POINT BEACH NUCLEAR PLANT, UNIT NO. 2

Amendment No. 40
License No. DPR-27

ATTACHMENT TO LICENSE AMENDMENT NO. 40
CHANGES TO THE TECHNICAL SPECIFICATIONS
FACILITY OPERATING LICENSE NO. DPR-27
DOCKET NO. 50-301

SAFETY EVALUATION BY THE OFFICE OF NUCLEAR REACTOR REGULATION
SUPPORTING AMENDMENT NO. 40 TO FACILITY OPERATING LICENSE DPR-27
WISCONSIN ELECTRIC POWER COMPANY
POINT BEACH NUCLEAR PLANT, UNIT NO. 2
DOCKET NO. 50-301

FIGURE 15.3.1-3

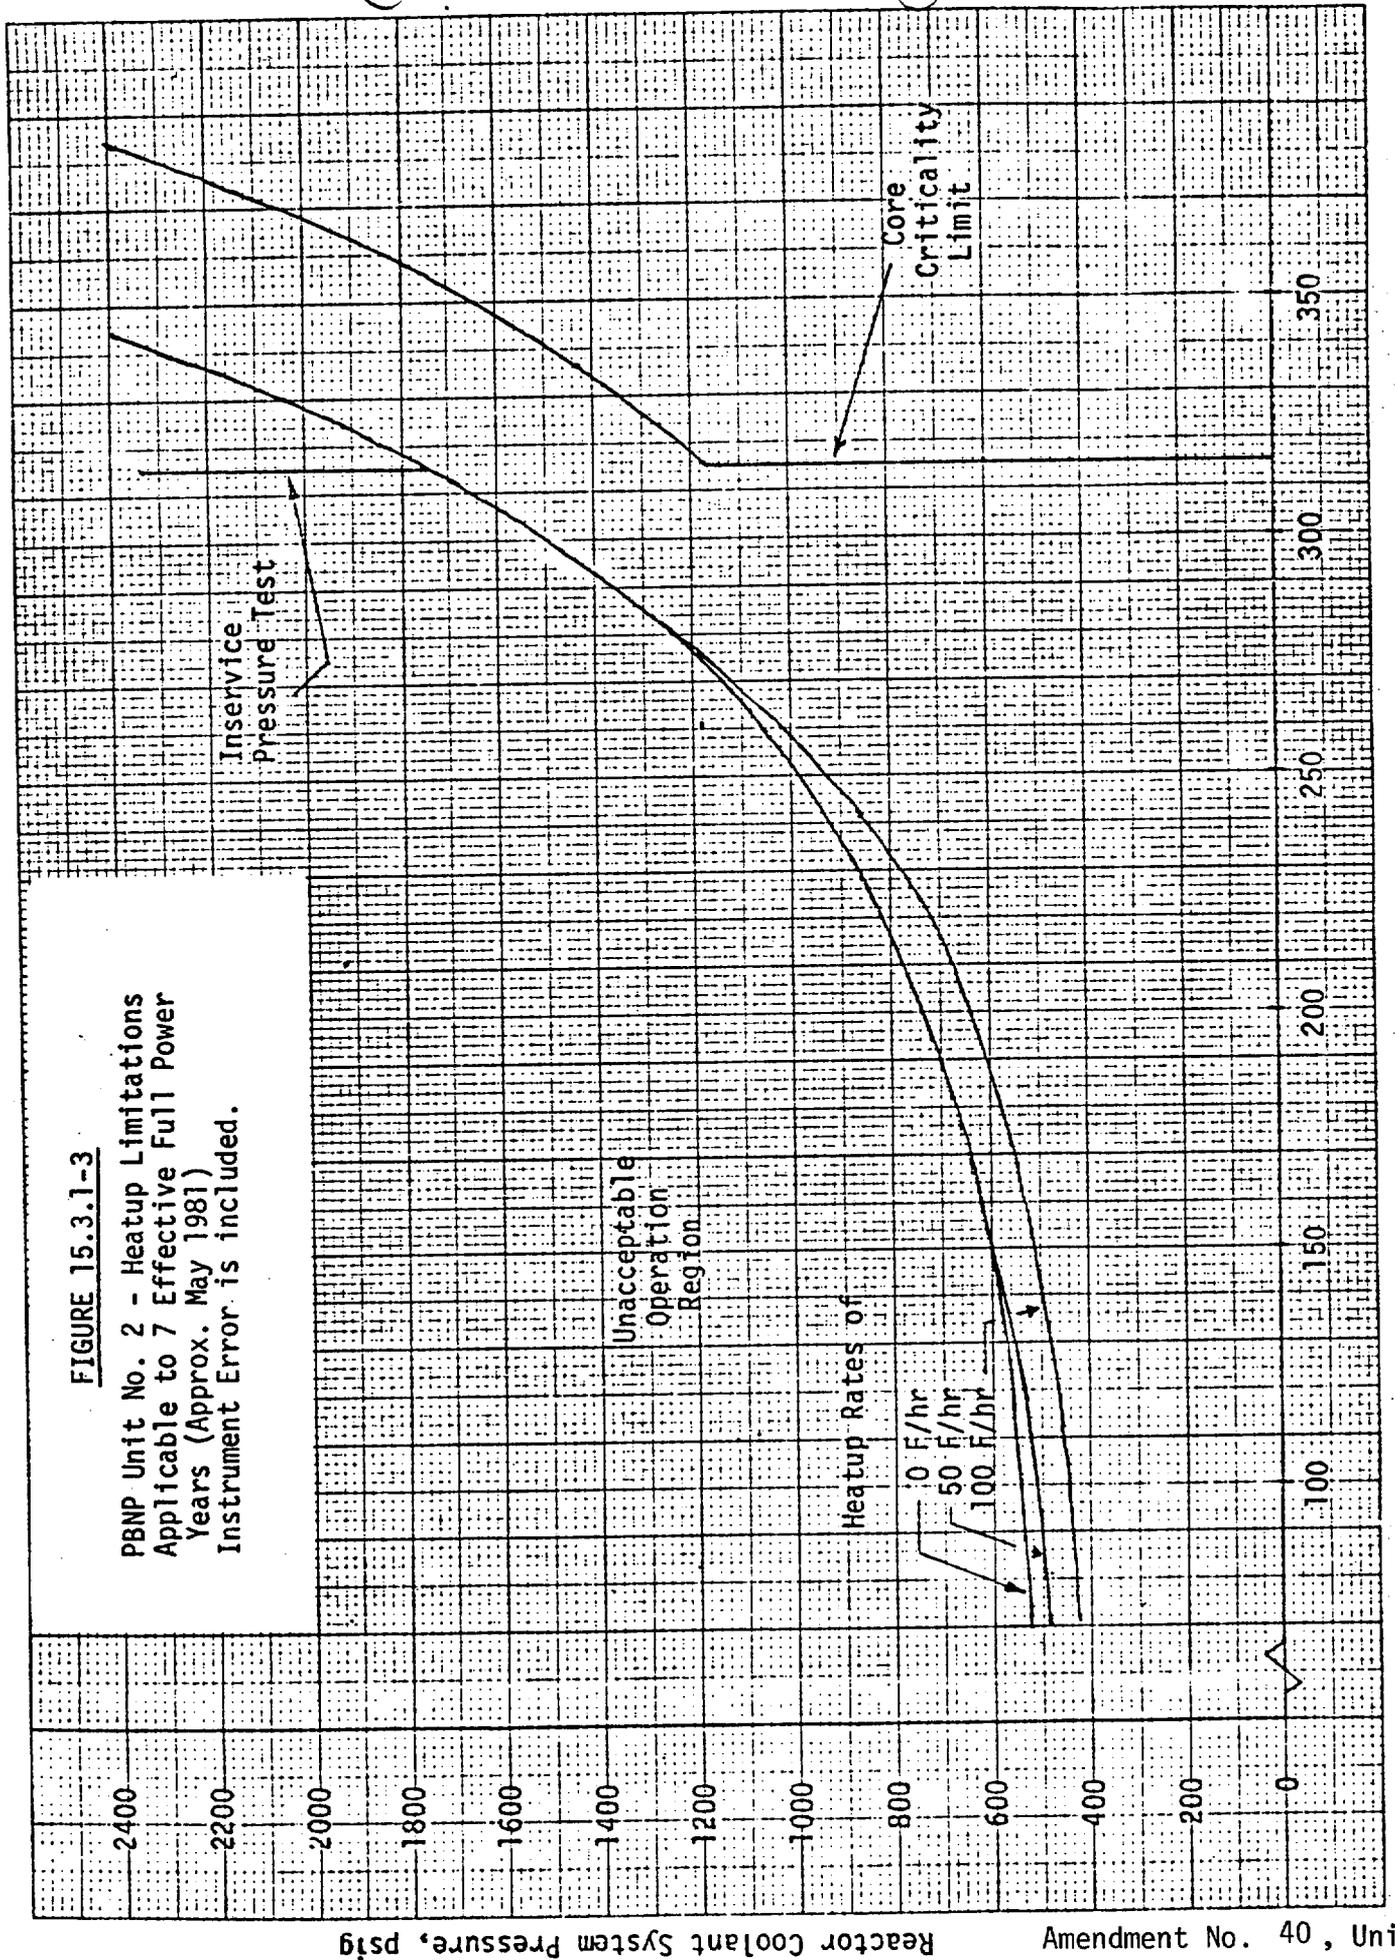
The amendment revises the reactor coolant system pressure-temperature heatup and cooldown curves to be applied up to seven effective full power years for Unit No. 2.

1. Remove Table 15.3.1-1 and Figures 15.3.1-1 and 15.3.1-2 (no replacements).
2. Remove Figures 15.3.1-3 and 15.3.1-4 and replace with revised figures bearing the same numbers.

PBNP Unit No. 2 - Heatup Limitations
Applicable to 7 Effective Full Power
Years (Approx. May 1981)
Instrument Error is included.
